NORTHERN BEACHES LOCAL PLANNING PANEL

WEDNESDAY 21 JUNE 2023

ITEM 4.1	DA2022/1874 - 26 ELTHAM STREET, BEACON HILL - ALTERATIONS AND ADDITIONS TO A DWELLING HOUSE.
AUTHORISING MANAGER	Adam Richardson
TRIM FILE REF	2023/366626
ATTACHMENTS	1 ↓ Assessment Report 2 ↓ Site Plan & Elevations

DEVELOPMENT APPLICATION ASSESSMENT REPORT

Figure 1. Wall height non-compliance.

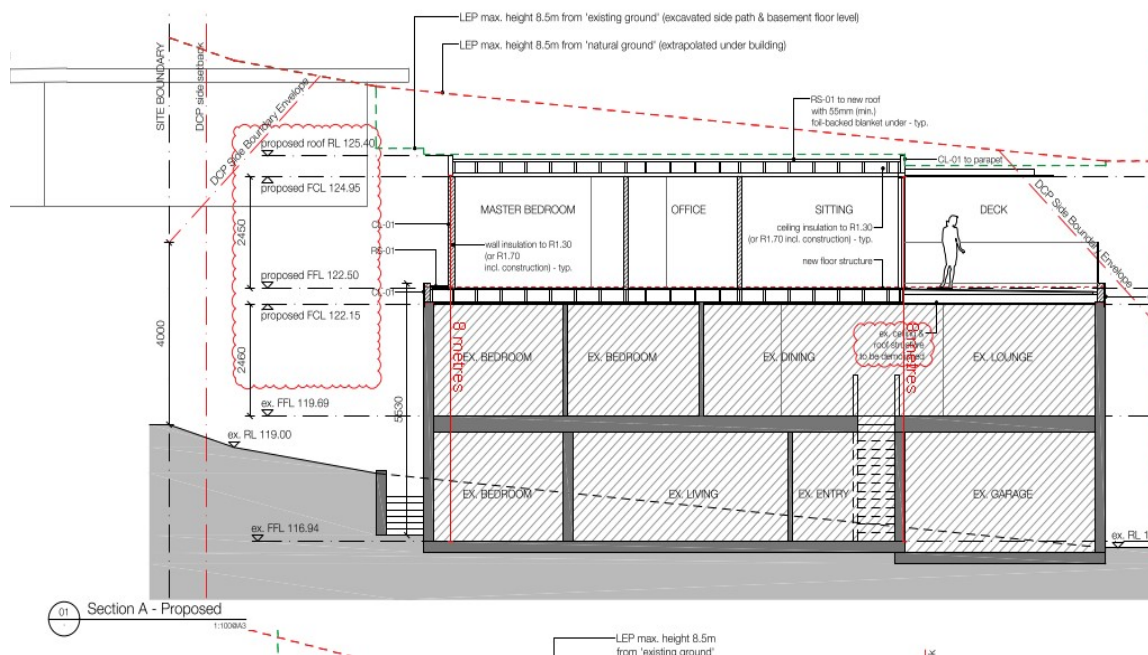
The DCP requires a maximum wall height of 7.2 metres. The proposed development has a maximum wall height of 8.0 metres at it highest point.

The second floor addition, as visible from the street, progressively steps in as the wall height exceeds 7.2 metres, while also incorporating, fenestration, balconies, landscaping, eaves and changes in materials to break up built form. The proposed addition is contained within the prescribed building envelope and appropriately set back from the boundaries to minimise the visual impact when viewed from adjoining properties. In addition, the external colours and materials consists of dark and earthy tones, which harmonise with the natural environment and will provide an appropriate transition of development from the adjacent reserve to the east. Overall, the proposed height is considered to be compatible and commensurate with the existing detached development within the locality and will not give rise to any unacceptable visual impacts.

Figure 2. Extent of northern side boundary envelope non-compliance.

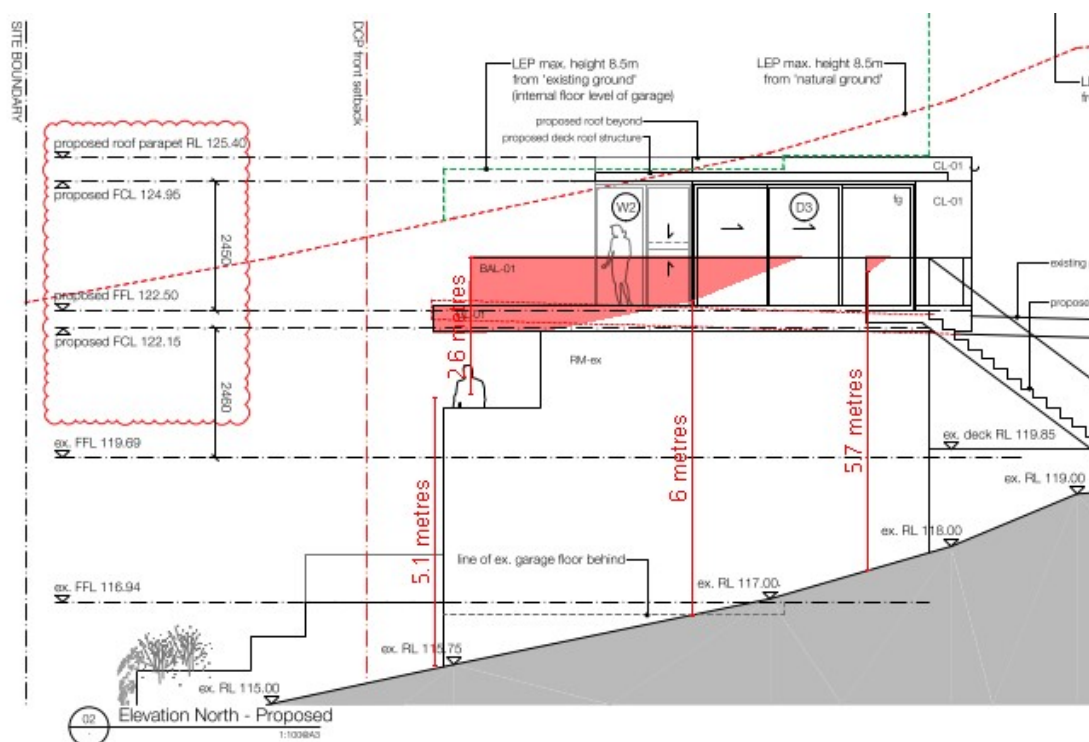
The proposal has two encroachments on the northern elevation measuring up to 2.6 metres in height. This represents a maximum variation of 65%.

The proposed addition is consistent with other two-three storey dwelling houses within the locality. The second floor balcony complies with WLEP's 8.5 metre height limit and side setback controls, which ensures that the development does not become overbearing upon adjoining properties. Furthermore, the proposal's design incorporates various materials and architectural features to provide visual breaks along the non-compliant wall planes. Overall, the proportions of the encroaching elements are not considered to be unreasonably scaled or bulky. It is noted that the majority of the encroachment is the balcony balustrades, rather than expansive building mass with the upper storey.

The spatial separation proposed between buildings is considered appropriate within the low density setting. It is acknowledged that the proposal includes a second floor balcony that partially encroaches the side boundary envelope, however, these encroachments generally occur at the front of the development and for this reason does not provide direct and close views into adjoining windows or private open space. Furthermore, the submitted shadow diagrams demonstrates compliance with WDCP's access to sunlight control. Overall, it is considered that the proposal ensures adequate light, solar access and privacy by providing reasonable spatial separation between buildings.

FIGURE 1: Extract of DWG 0628-DA112 01 (longitudinal section) showing 9.5m building height plane and building relationship

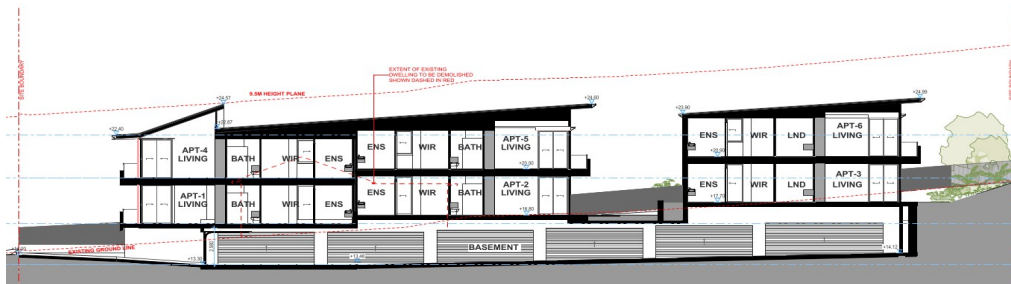
****Note:** Maximum height is measured to the ridge of the projecting skylight at RL24.57 as seen in DWG 0628-DA112 01 by Popov Bass below:

Figure 2 - June 21 9am Eye-of-the-Sun View (Existing on left and proposed on the right).

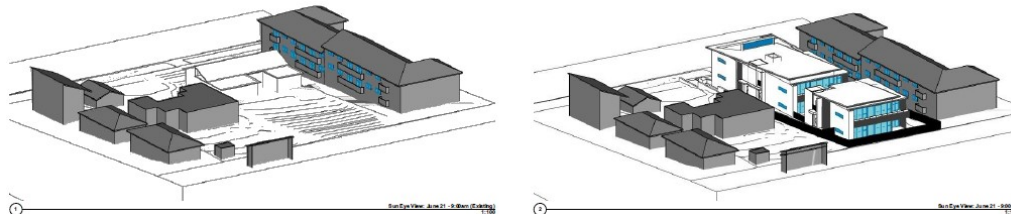
As demonstrated in Figure 2 below, the proposal would result in four of the ground floor unit balconies (and principle private open space) receiving no sunlight at 9am. This would result in the private open space of four adjoining dwellings receiving less than three hours of sunlight between 9am and 3pm on June 21, which does not comply with the requirements of this control.
